Re: Docket No. 461 - CSC 461 Greenwich Substation and Line Project

Response to HD-01 Late Filed Exhibits dated 10/06/2015
LF-001 and 002

TITLE
 GREENWICH S/S AND LINE PROJECT
 BRUCE PARK OPTION
 ROW CROSS SECTION DRAWING
 GREENWICH, CT

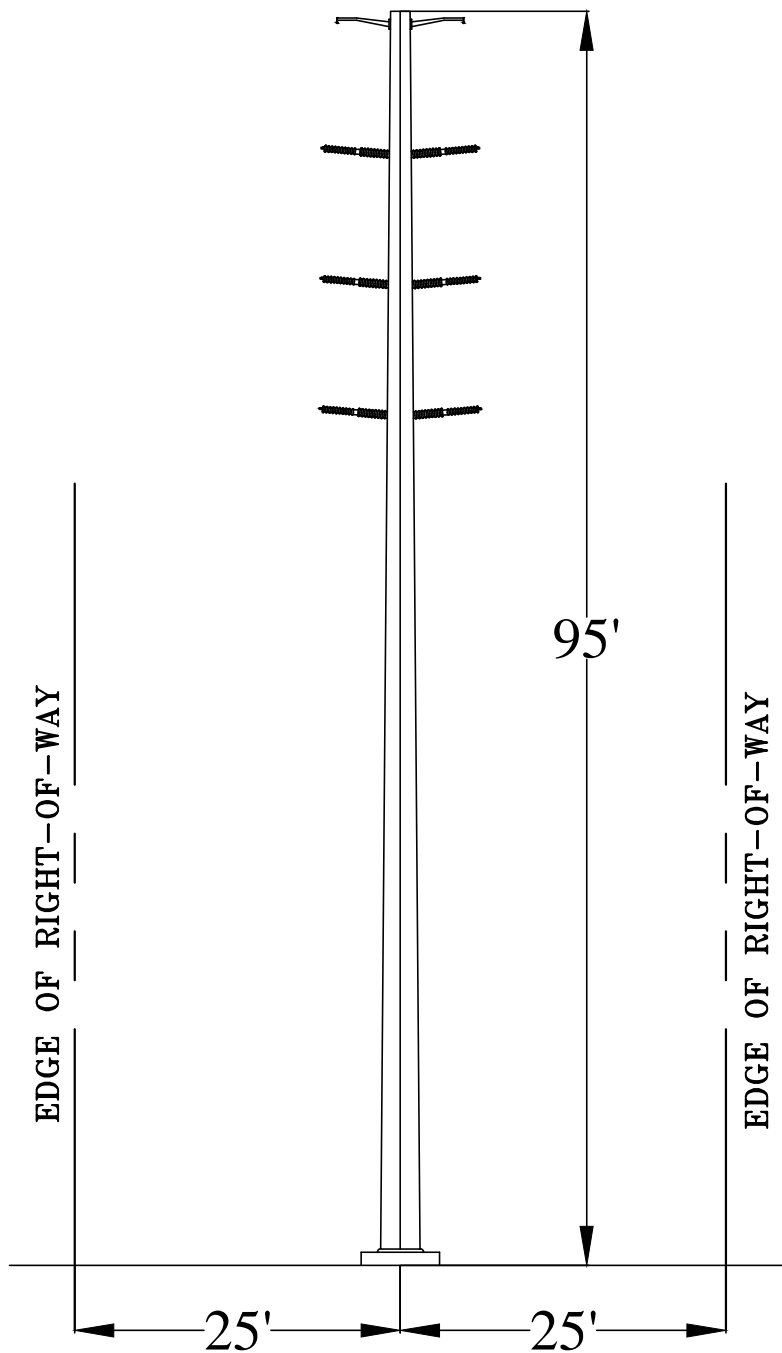
To avoid underground transmission near the water features in Bruce Park review an overhead option that crosses to the north section of the park or south of the interstate. Provide visual simulations, diagram, cross section and minimizing the ROW width.

The Company evaluated an overhead transmission line segment crossing along the north section of the Bruce Park located just south of the Interstate 95 ROW and a variation extending the overhead line segment that would cross the I-95 and railroad corridors overhead. The estimated costs of these options would be approximately \$67 million and \$60 million, respectively, which is approximately \$5-12 million less than the estimated cost of the underground transmission lines along the Preferred Route including Bruce Park.

Bruce Park Overhead - requires two transition stations (approximately 75 feet by 75 feet each), one near Kinsman Lane and the second along Davis Avenue, where the overhead transmission line segment would transition to underground high pressure fluid filled (HPFF) transmission lines. These underground lines would extend along the Preferred Route from the respective transition stations to Cos Cob Substation to the northeast and to the proposed new Greenwich Substation to the west. This overhead line segment would create a hybrid overhead/underground line route variation.
